The Tree by-law does not work

Prepared for the Lexington Tree Committee

August 10, 2023

The Tree by-law does not work: 5 Munroe Rd

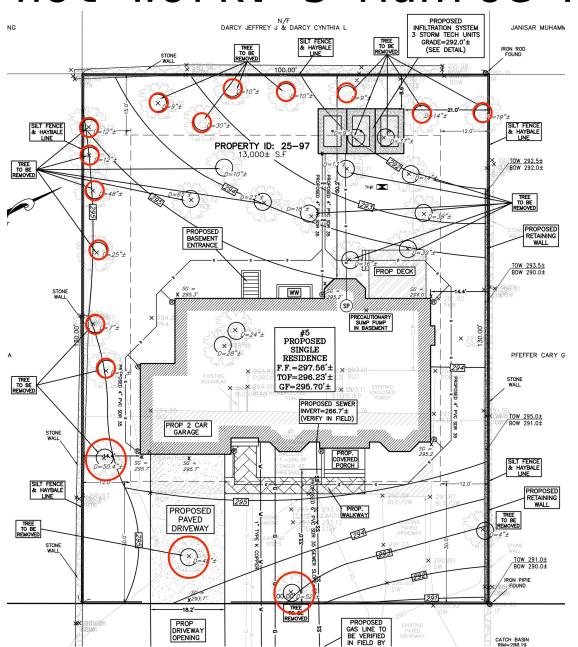
- Why were 16 protected trees cut on this lot?
- The site now looks "bare"

Appendix: 37 Munroe Rd

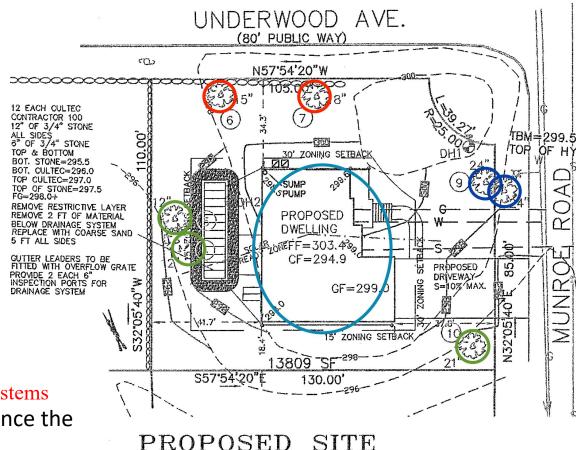
Why was the 21" "green" tree approved for removal?

[...] answers to questions [...] also regarding 37 Munroe Rd [...] Yes. Root systems would be impacted. David Pinsonneault emailed (in red): INCORRECT, since the 21" tree was 30 ft away from the new house

Fine of a few \$100s ("red" trees illegally removed) has NO impact on builder of a \$2-3 million new house

You can see how the site now looks "bare"

The owner was approved for 5 trees to be removed: 21", 12", 12", and 2-24" hazard trees. He would have had to plant 15-3" trees. But he removed two additional trees that on the plot plan that he said he thought he had told me about. They are 15" and 18". He will be given a fine for the two trees that were removed as well as the replanting and the removal fee. [...]

Appendix: 25 Munroe Rd

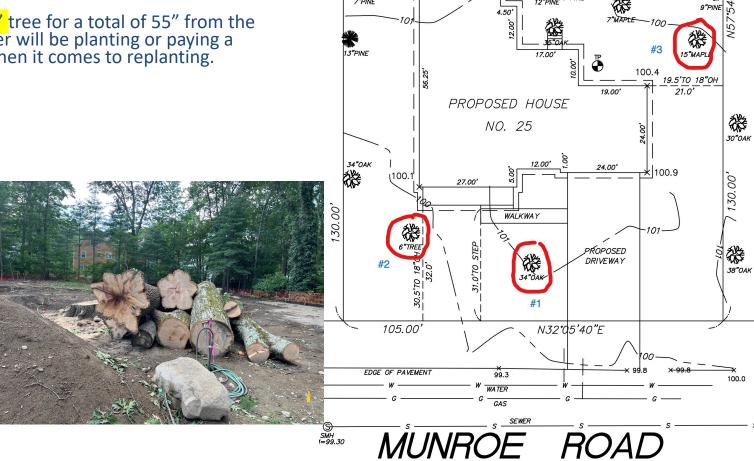
Why was the 34" oak approved for removal?

This is a small lot that will have impact on the root system. David Pinsonneault emailed: INCORRECT, since the 34" oak was 25 ft away from the new house, more than the 15 ft

The contractor was approved to remove a 6", 34" and a 15" tree for a total of 55" from the setback areas. It is uncertain at this time weather the owner will be planting or paying a mitigation fee. Finnegan has done a good job in the past when it comes to replanting.

Appendix: 5 Munroe Rd

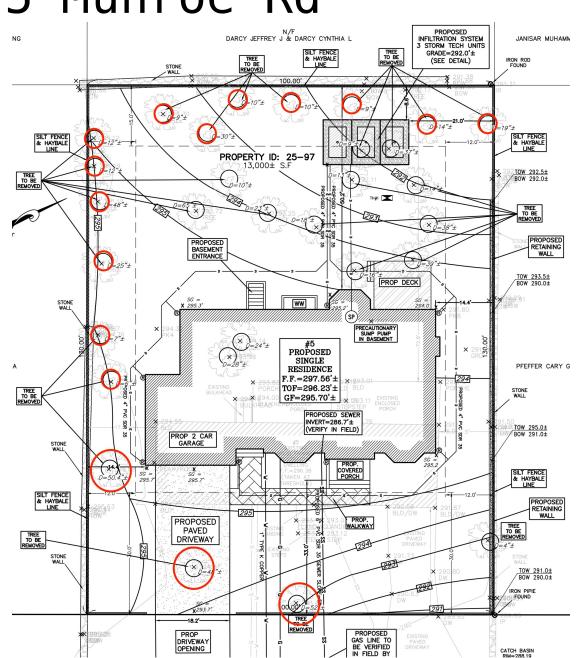
Why did the 7 "red" trees (DBH 30", 19", 14" 10", 10", 9", and 9") behind the new house and the 7 ones (DBH 12", 12", 48", 25", 7", 6", the "big red" 50.4") on the left side, and the "big red" 52" in front have to be removed?

My answer: so the builder can save time and money maneuvering his construction equipment on a clear-cut lot

The 48" DBH tree shown on the driveway footprint could also have been saved if the Tree Warden had convinced the builder to flip the house.

This is a perfect example of a clear-cut lot, like 37 Munroe Rd
